Staff Report

RE: Crystal Loft Townhomes – 214 S. 13th Ave.

DATE: September 10, 2018

Project Name: Crystal Loft Townhomes

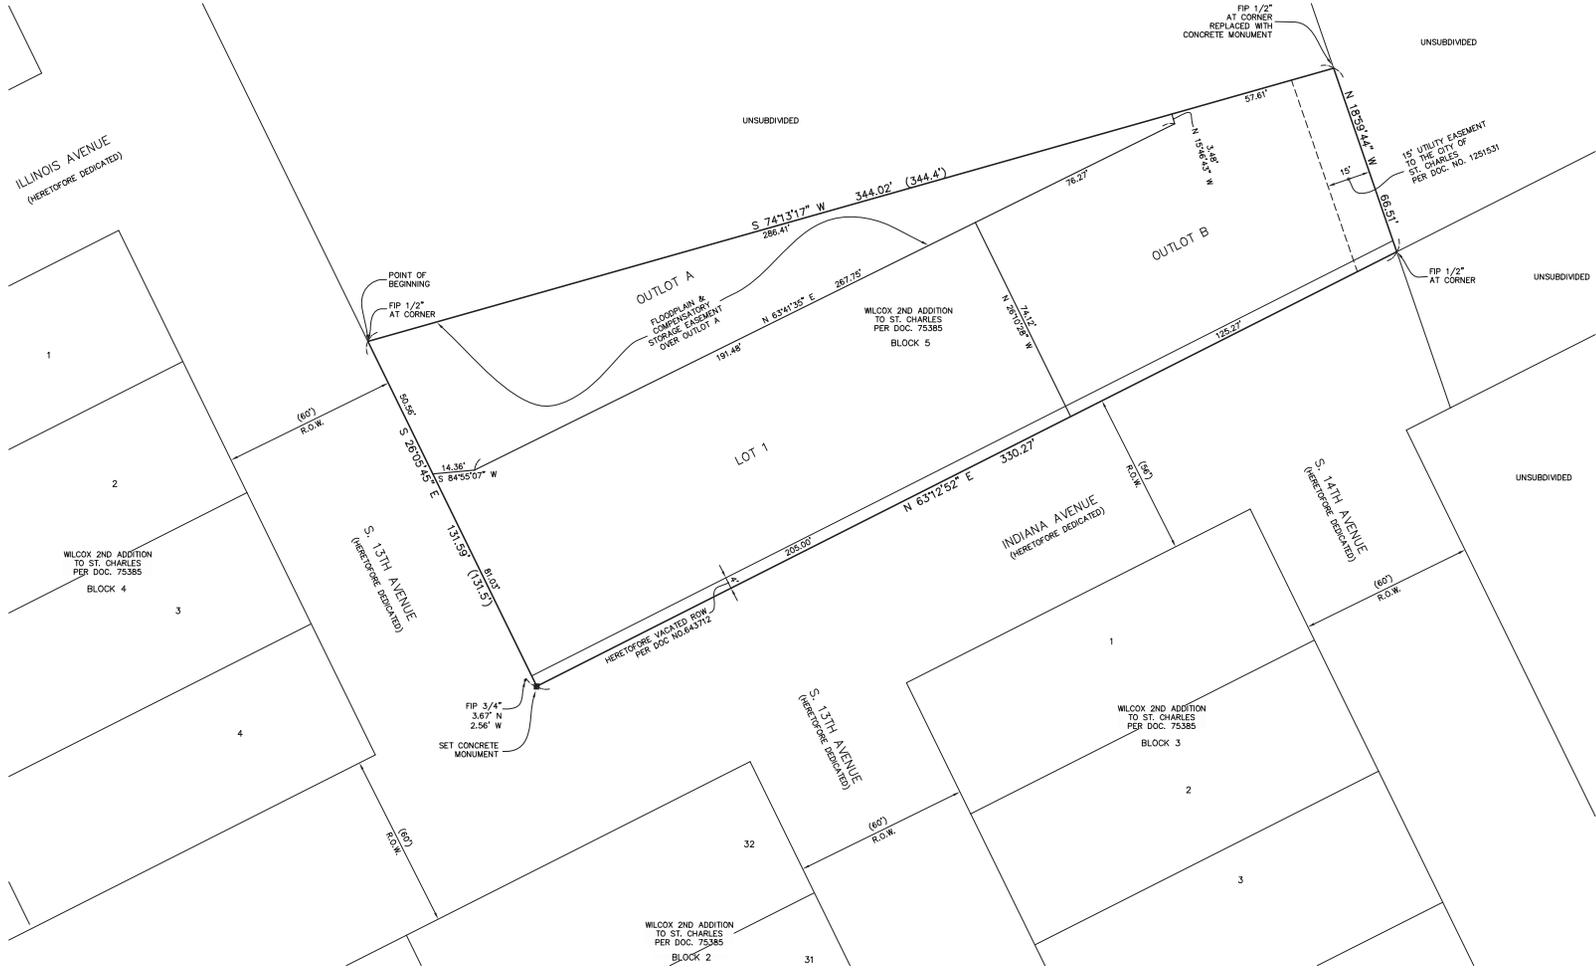
A revised Final Plat of Subdivision has been submitted for Phase 1. Proposed Lot 1 encompasses the existing building, decks, garages and a portion of the drive aisle. Proposed

- Change the zoning designation note to RM-3 General Residential District & PUD.
- Owner’s Certificate – remove the By and Address lines and replace them with the Signature and Title lines.
- Notary Certificates – Add, “Given under my hand and Notarial Seal this…” before the date/signature.
- Does a concrete monument exist at the northeast corner, or is a monument proposed in that location? If not, amend the notation.

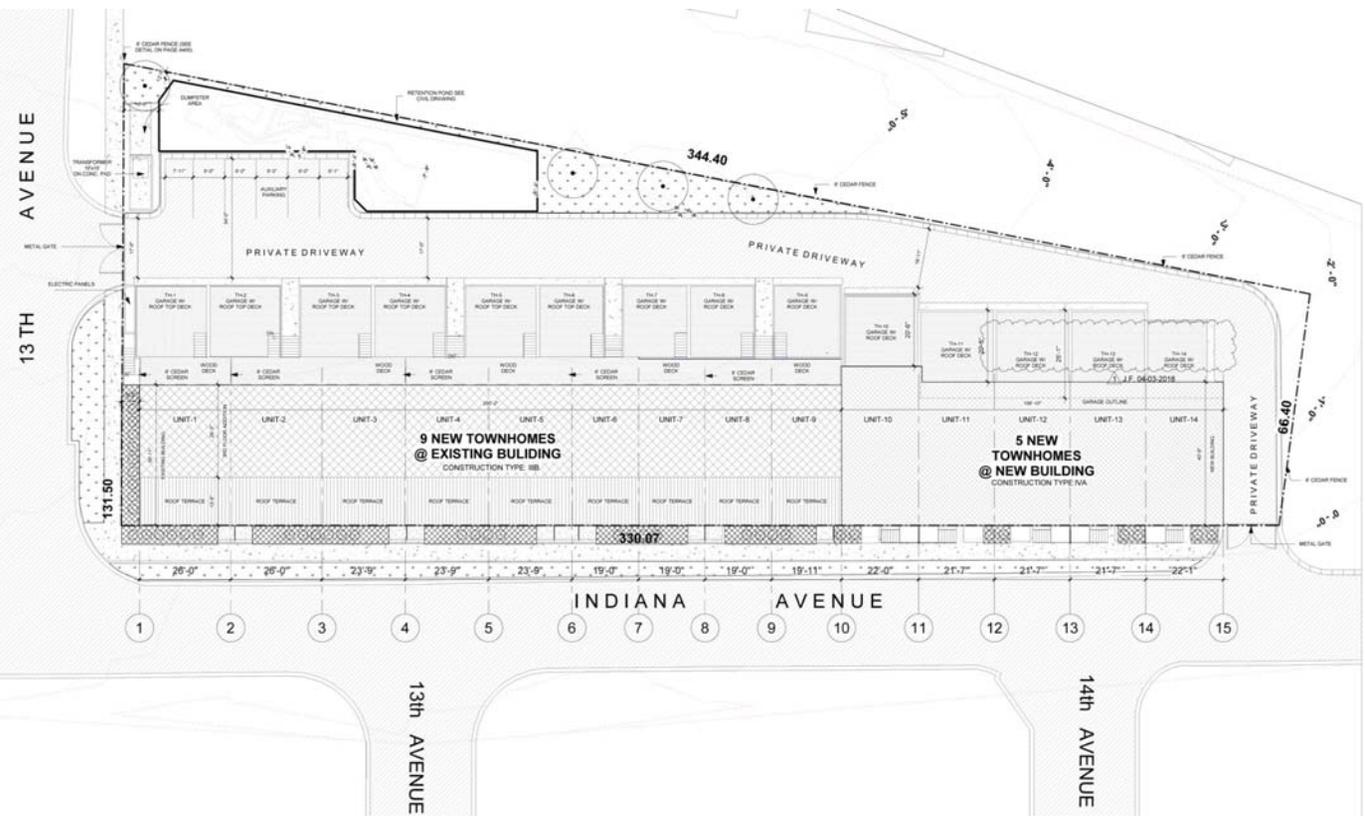
A revised landscape plan has been submitted. The rear courtyards have been removed, however due to the stormwater detention area, the total percentage of landscaped area has increased from 2,300 sf to 4,850 sf. Building foundation and street frontage landscaped areas are provided in the locations shown on the approved plan. However, there is less variety in plantings than on the approved plan.

- The plan will need to be revised to add more shrubs and perennials along the building foundation, per the approved plan, in order to comply with the PUD Ordinance.

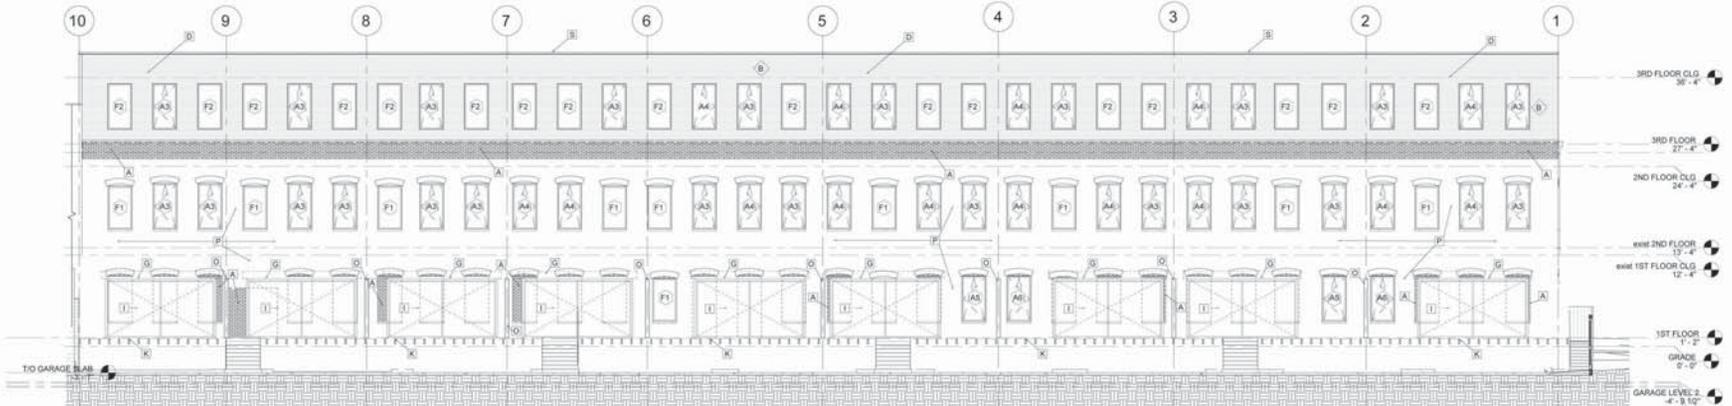
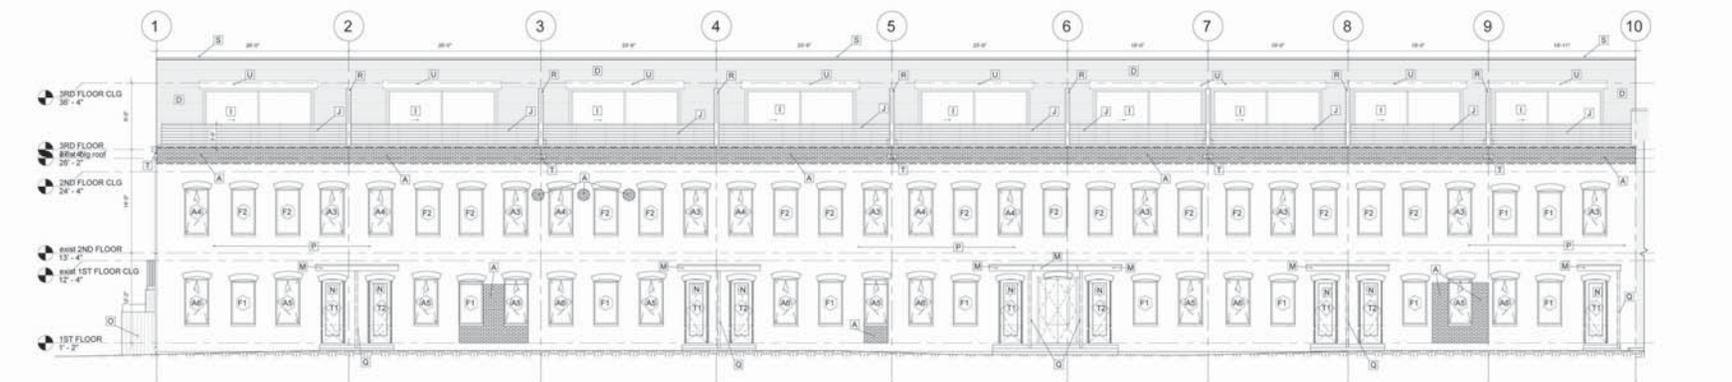
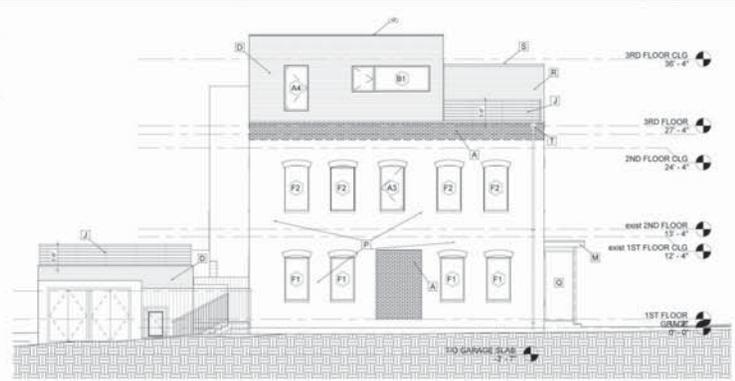
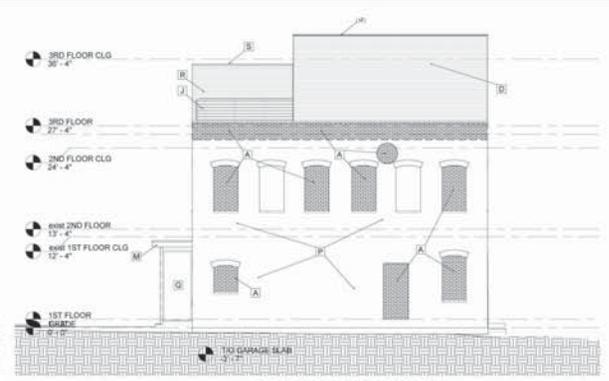
Revised architectural elevations have been submitted. Buildings in the RM-3 District are subject to the Design Review requirements of Section 17.06.050 Standards and Guidelines – RM1, RM2, and RM3 Districts. Corrugated metal siding is now proposed instead of fiber cement. A rendering of the proposed siding has been provided. This type of material is not specifically referenced as an approved or prohibited material, however “architectural metal” is permitted. The proposed material can be considered to fit within that category.
